Product Notification – DOC #1377742

Affected Parts: Y210-6005, Y210-1, Y210-2, Y210-9, Y210-CM056

Image 1: Left – before adding shear gate. **Right** – after adding shear gate.

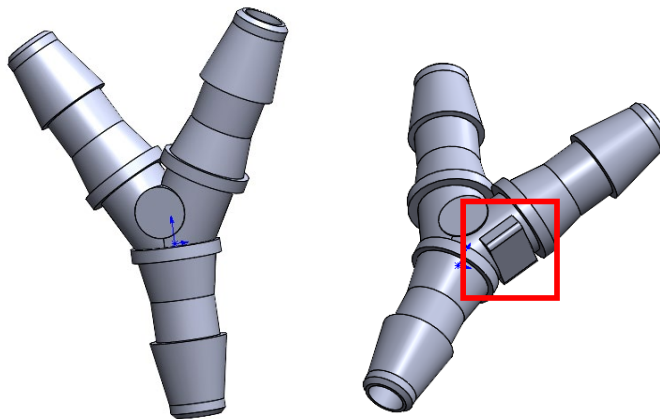
Nordson MEDICAL has made an improvement to the mold that produces the above parts to increase capacity in this time of high demand. The change involves updating the mold from a tab gate, which requires manually removing product from runners to a shear gate that will automatically degate the product from the runners. You may observe a new feature on the center grip section of the product, which is added specifically to allow for the shear gating feature.

This will be a running change as there is no change to product function, material or sealing surfaces, but you may observe product in the future that has this new feature as shown below.
